ADDENDUM #1

VICTORIAN SQUARE INFRASTRUCTURE IMPROVEMENTS PROJECT-SECTION 5

BID # 24/25-010 / PWP # WA-2025-137

| SHEET | C0.0 |

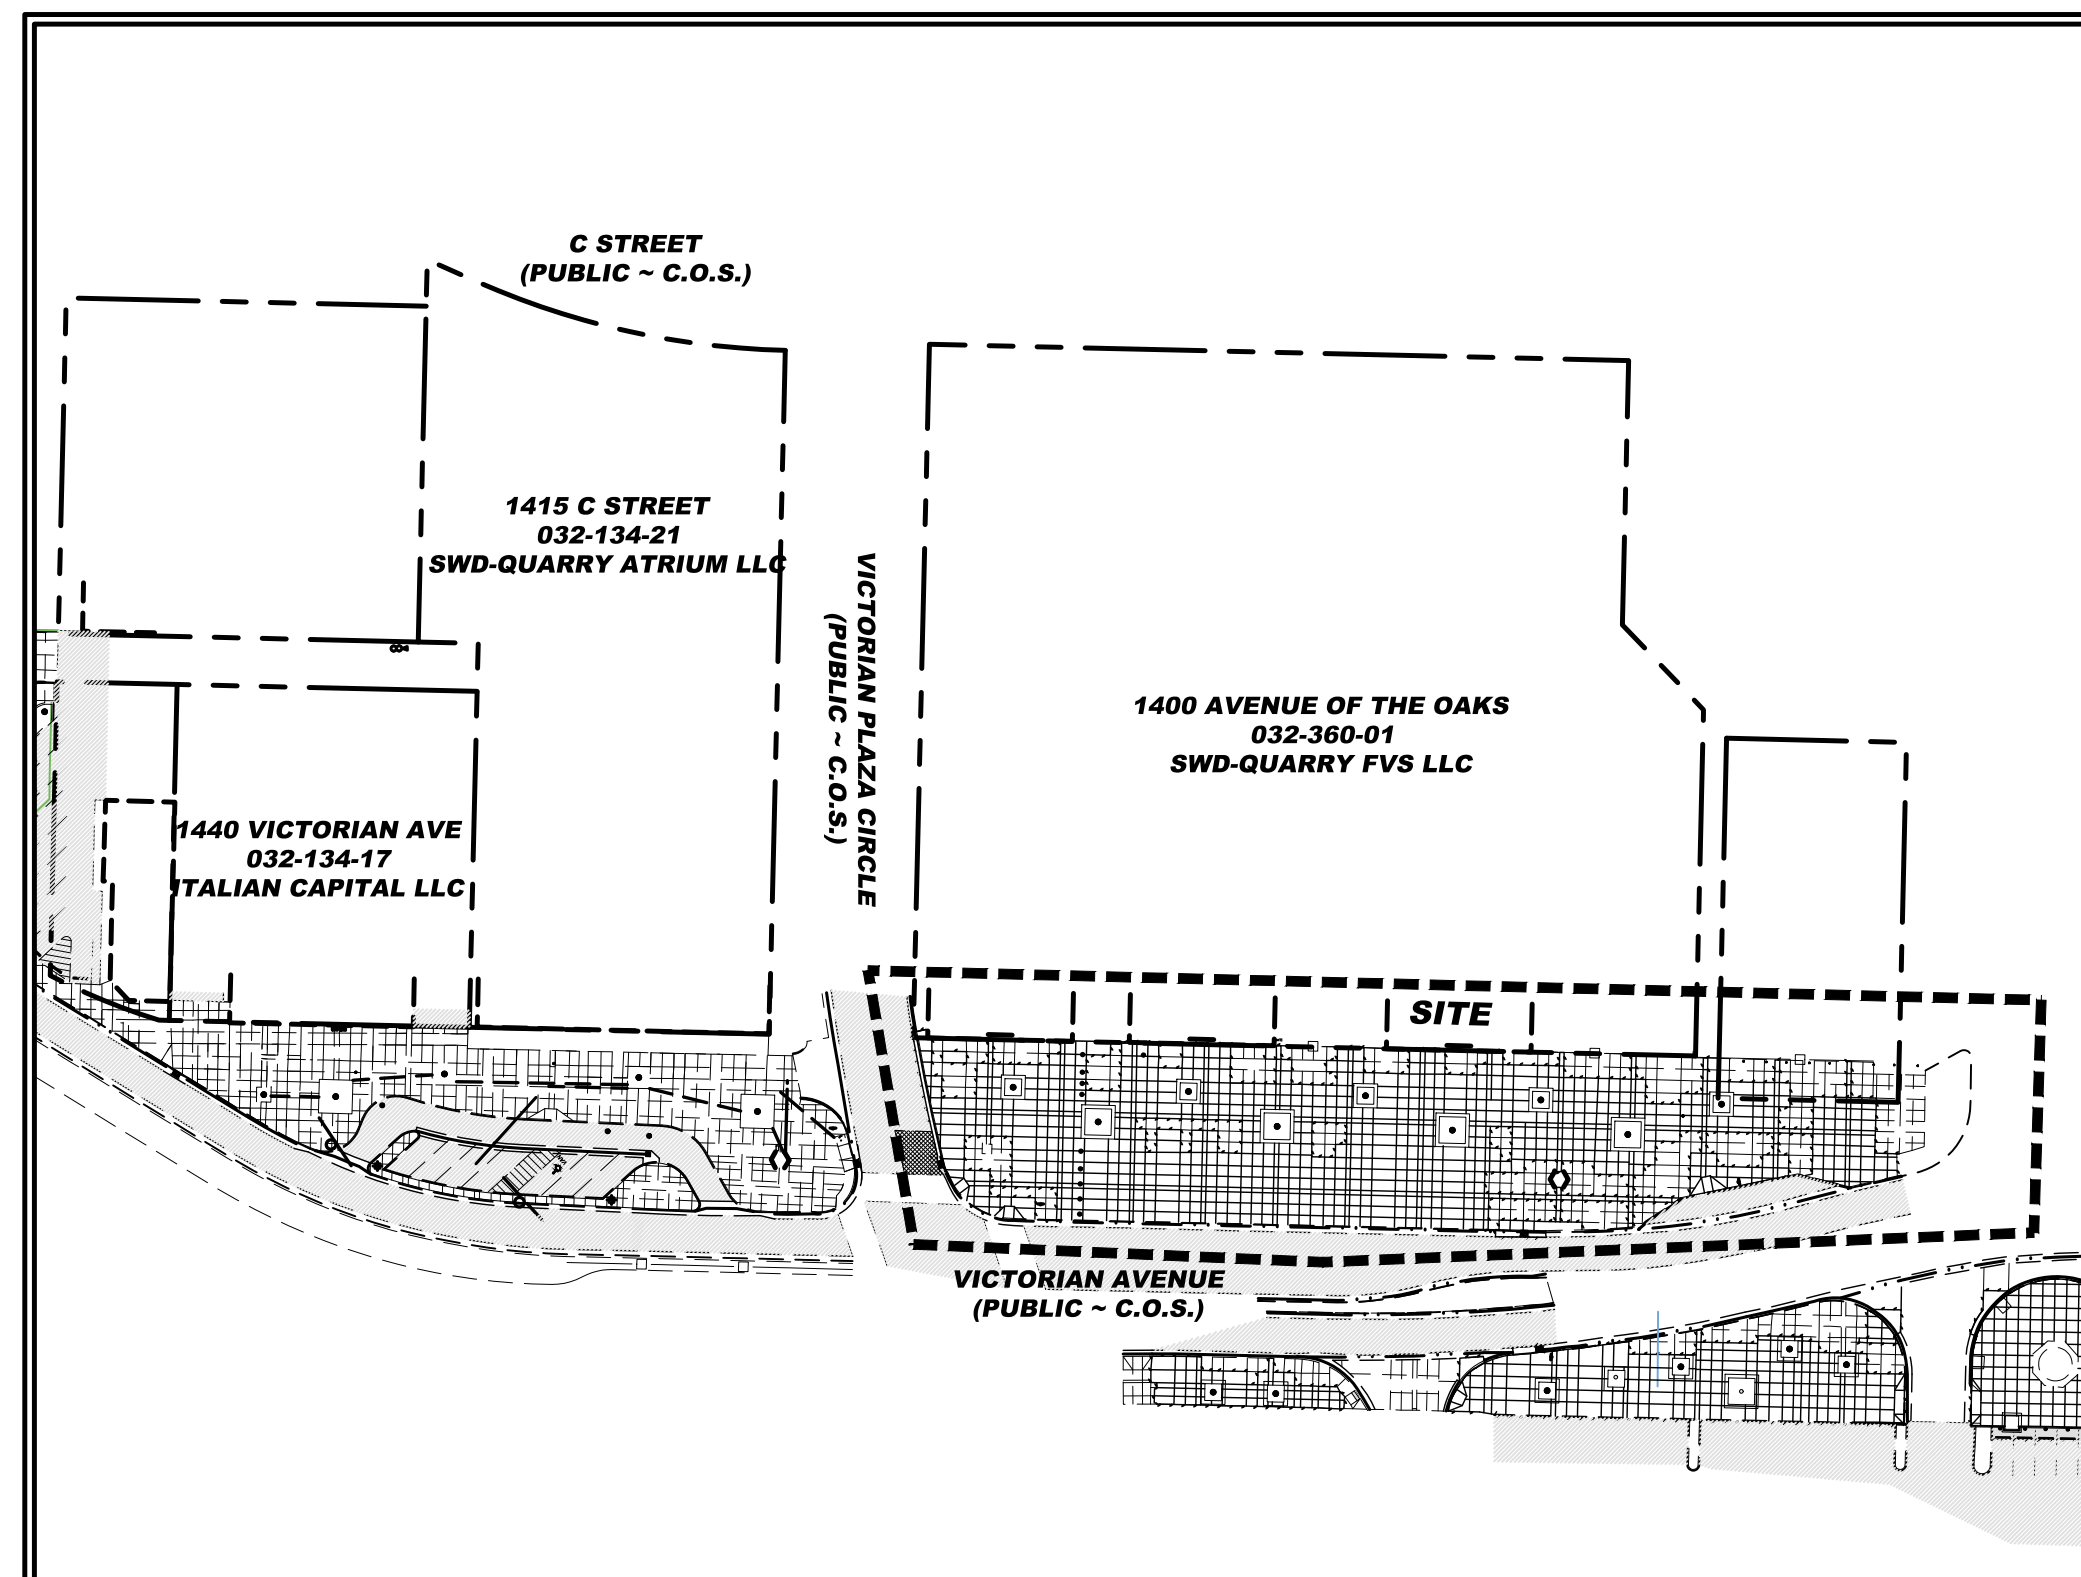
- a. Added sheet C5.4 – Civil Details to include form liner, planter box detail, stain, and patch detail. Included removable bollard installation on the east median at East Victorian Plaza Circle and Victorian Avenue.
- b. Added kiosk colors to site plan sheet C2.0 – Tiffany Tan and Transformer Green.
- c. Added note on sheet C2.0 referencing an additional removable bollard location that is detailed on the upper right corner of sheet C5.4.
- d. Changed “yellow” truncated domes to “red” truncated domes on sheet C5.0.
- e. Added a reference to new sheet C5.4 in the civil sheet index on sheet C0.0.

NOTE:
AN ADDITIONAL BOLLARD INSTALLATION LOCATION A PART OF THIS PROJECT IS LOCATED ON SHEET C5.4.

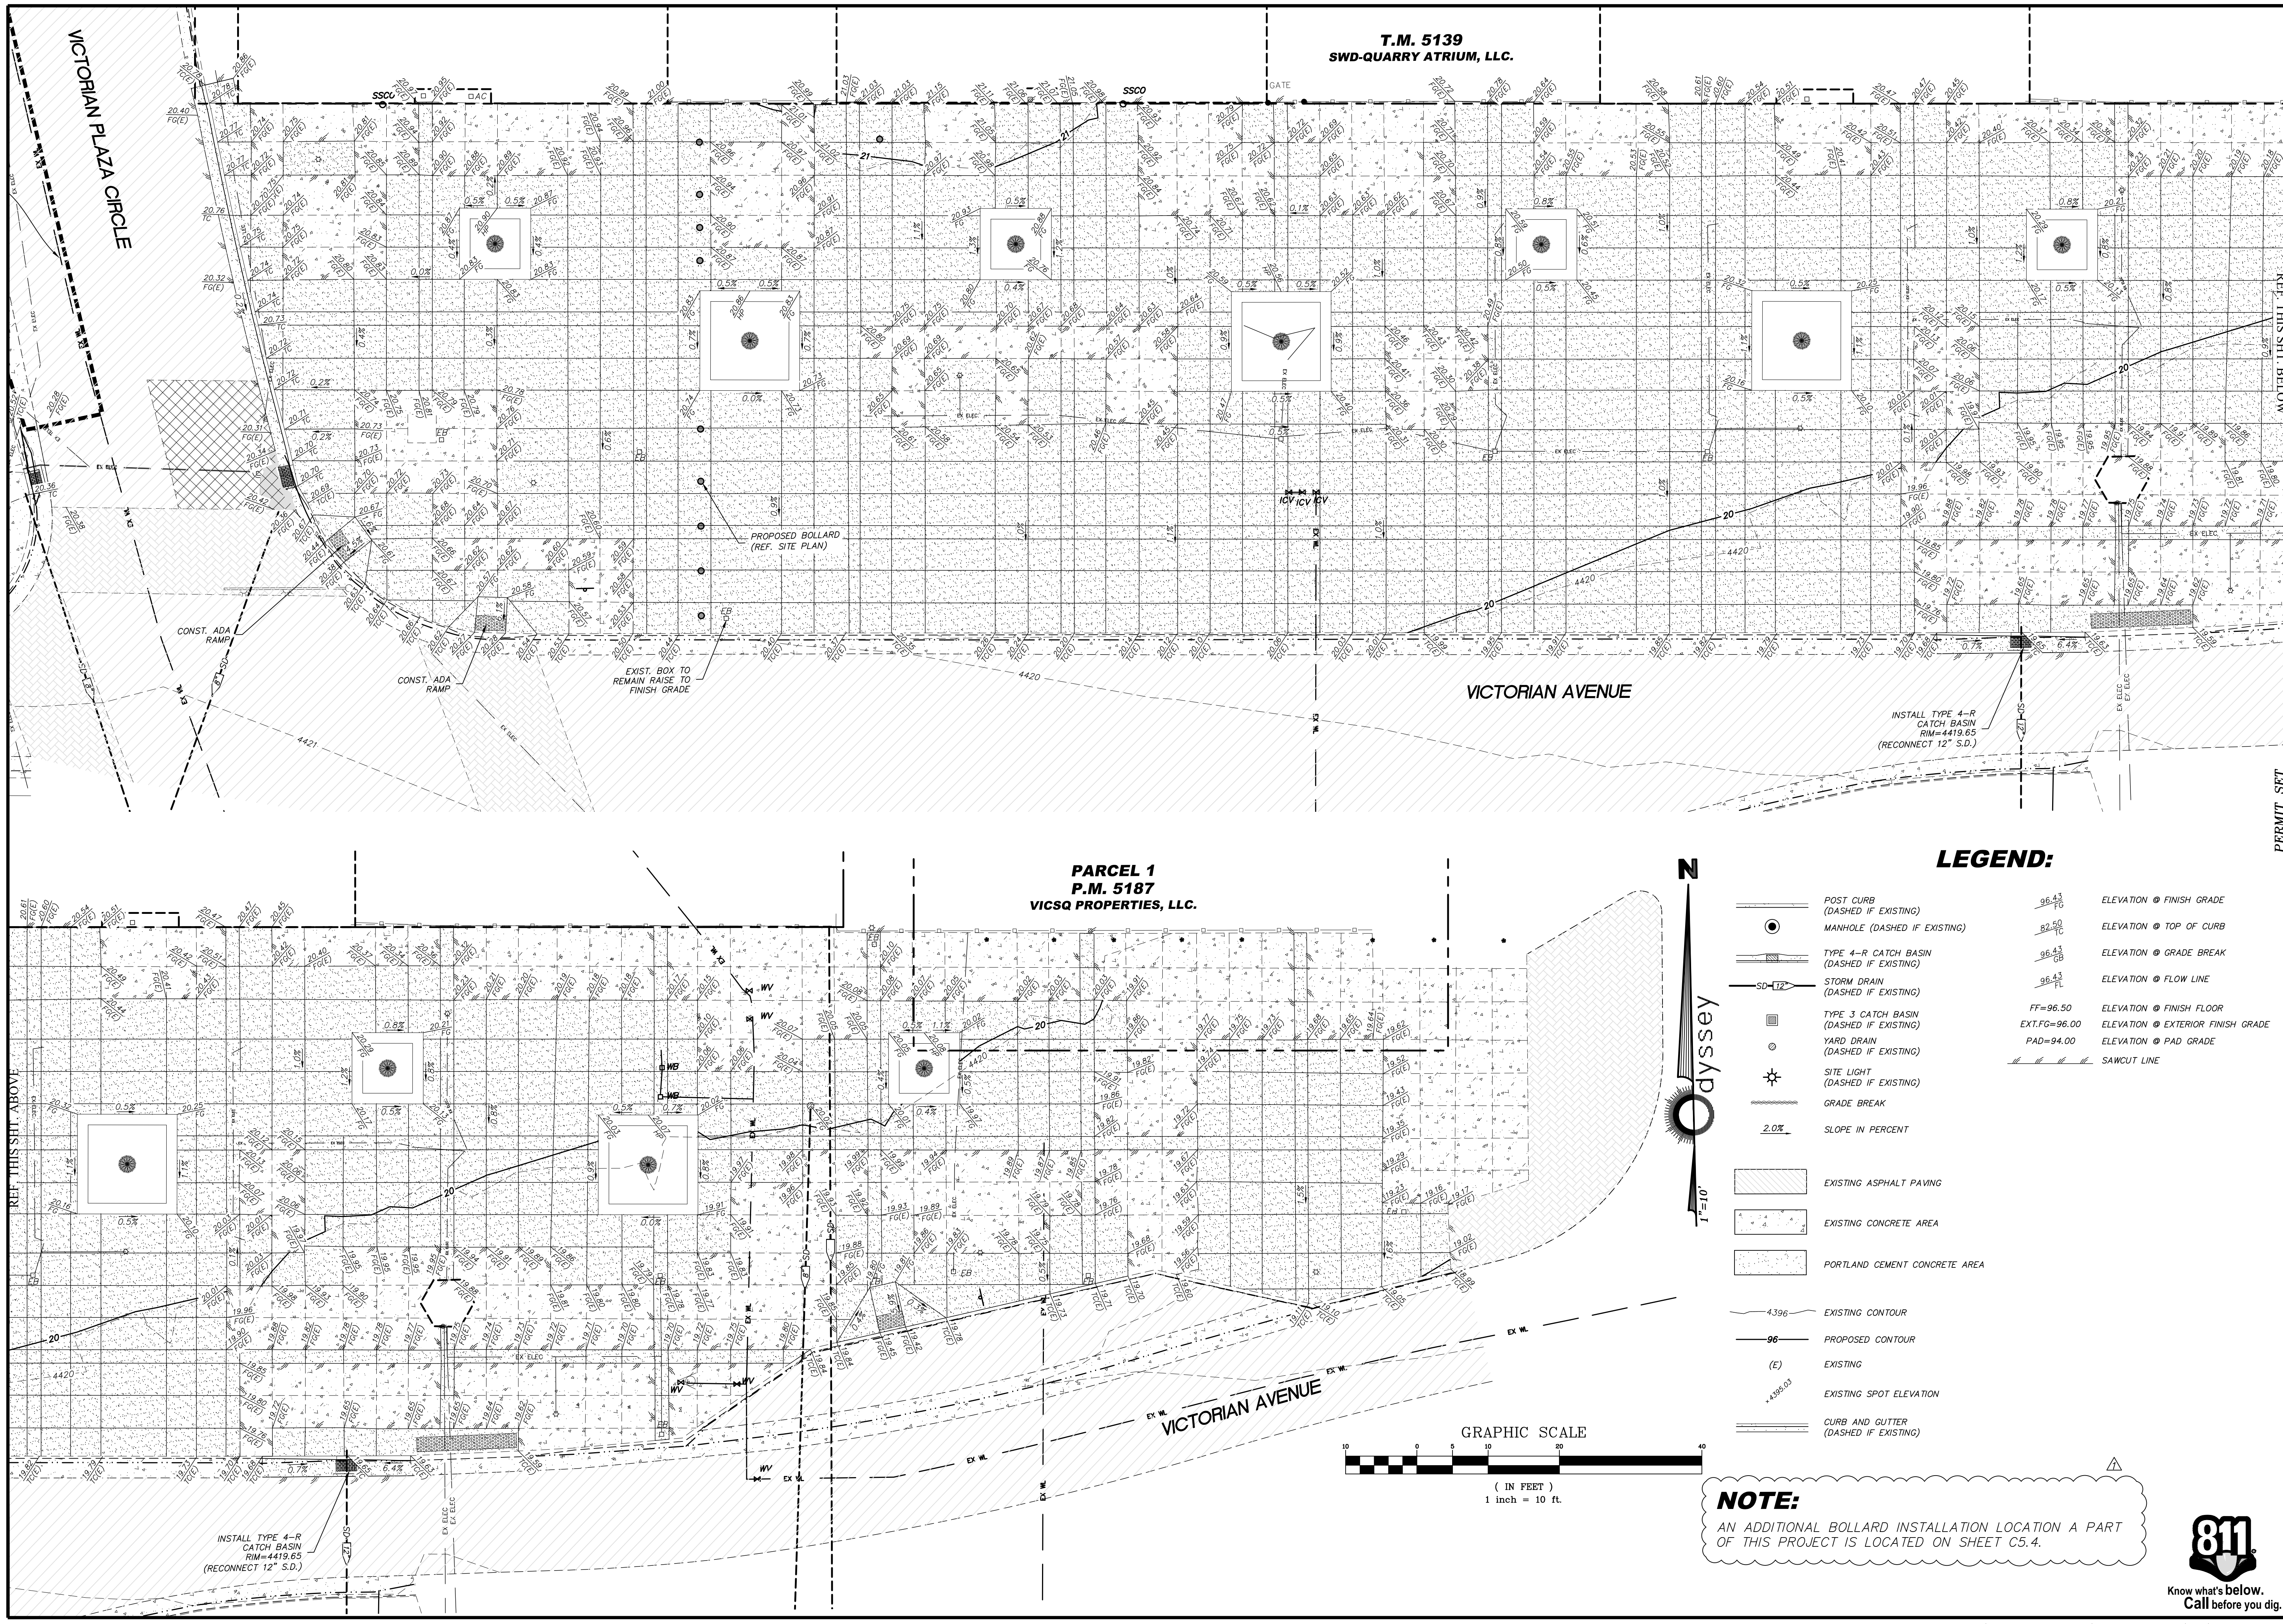
- 2) **I am unable to locate the bollard storage detail, it is mentioned in bid item “C8” but no detail on what exactly it is?** Bid item C10 and C12 include installing the bollard storage location. There are six permanent bollards, four removal bollards (three on sheet C2.0 and one on sheet C5.4), and one bollard storage location. The footing section of Detail “O” on sheet C5.2 is what will be installed for the bollard storage location. The location for the single bollard storage location is noted on Sheet C2.0 at the top of the sheet just to the east of the line of bollards.
